SB-10044699-6072SI M11 03 12
EngineJune 2012
Technical Service**SUBJECT****Resealing the Engine Oil Pan****MODEL**

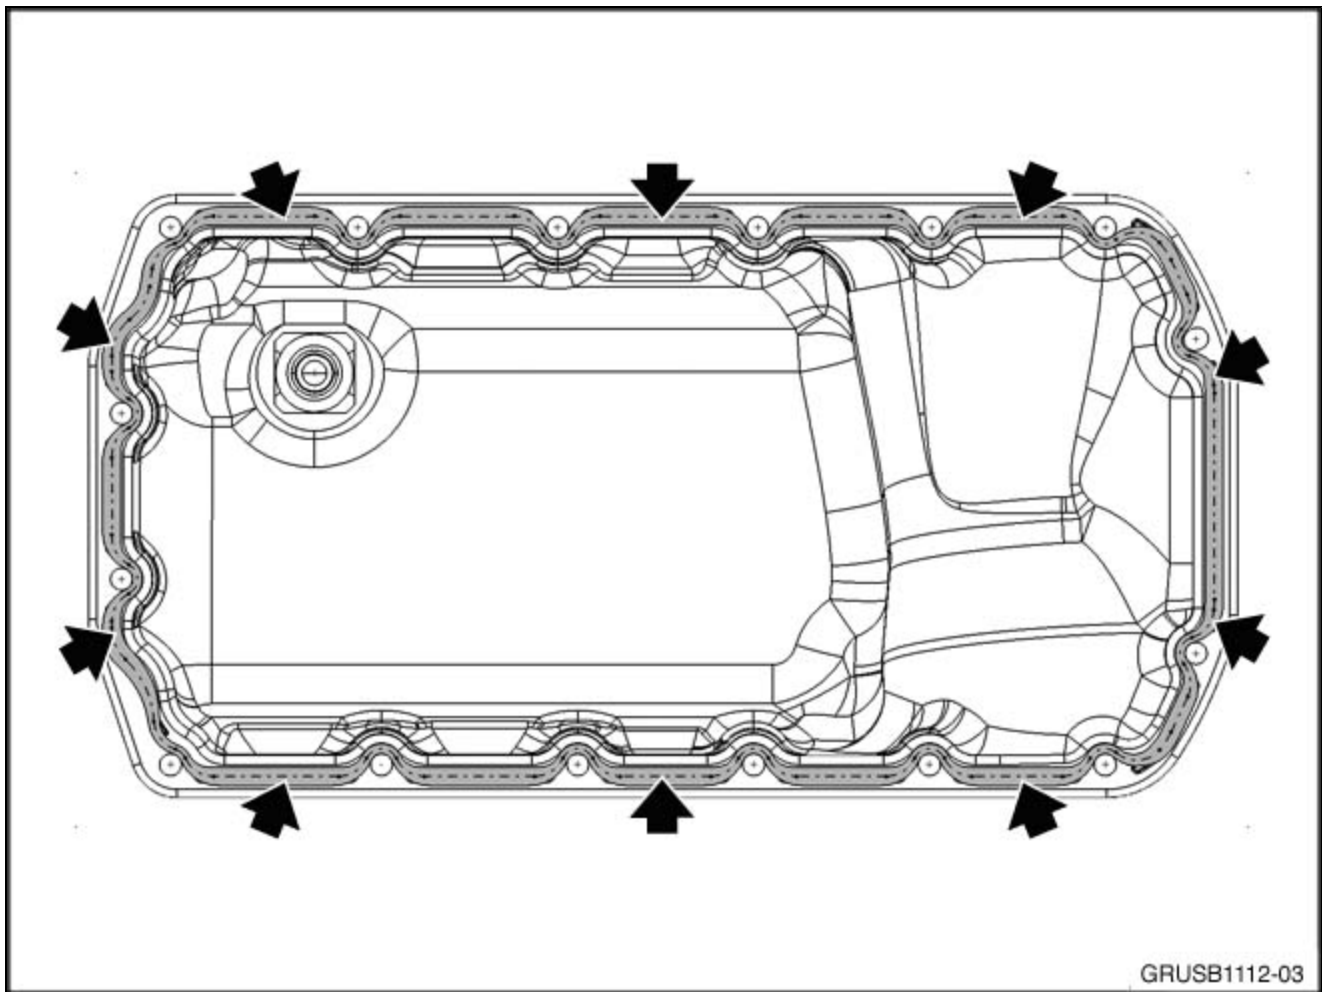
The replacement engine oil pan gasket available via EPC (P/N 11 13 7 565 928) should no longer be used when resealing the engine oil pan. A substitute flexible liquid sealing material, P/N 83 19 0 404 517 (Loctite 5970), should be used.

Removal of the engine oil pan can cause deformation (increased tolerances) of the sealing flange.

The flexible liquid Loctite sealer (P/N 83 19 0 404 517) is more adaptable for increased tolerances.

Apply Loctite 5970 (P/N 83 19 0 404 517) to the sealing surface of the engine oil pan. The bead of flexible liquid sealer should be approximately 2mm-2.5mm in height when applied. The sealing material should be applied to the engine oil pan on the inboard side of the drilled fastener holes. Refer to the illustration for proper flexible liquid sealer location.
